Hopper Door Pressure Reducing Manifold & Surface Cracks in Hopper Door Cylinder Buckets

Notice
XXXXX

PN: 206L20-A7 & A9 Hoppers 206F18, 206G06, 206J08 & 206H99
PN:5226177 & 5226178- Only A7 & A9 3CR12 Hoppers 206G06 & 206J08

- Door Cylinder Buckets 5226177 & 5226178:

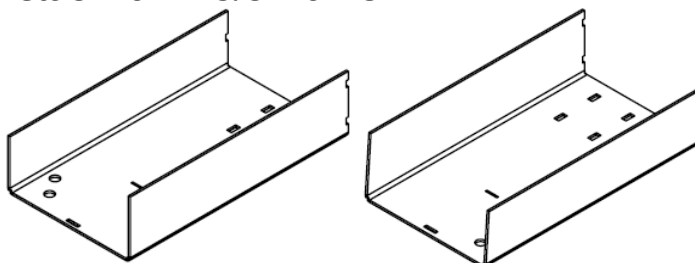
- **What**-Surface cracks have been found in the base material and paint on some A7 & A9 T4F 3CR12 hoppers along the interior bends of the hopper door cylinder buckets.

- **Why**-The issue resulted from a combination of an incorrect bend radius used during forming and a batch of material with higher-than-expected rigidity/hardness. Note, not all batches or materials are impacted.

Hopper Door cylinder Bucket Surface Cracks

- **Immediate Required Action**-All units with the hopper assemblies listed below need to be inspected for cracks immediately. If cracks are found, to prevent propagation, paint should be removed from the bends and the metal should be prepared for welding with the use of abrasives and a needle scaler. The entire length of the interior bend should be welded over to ensure proper penetration into the base metal. Once cooled, the surface should be prepared for paint and painted.
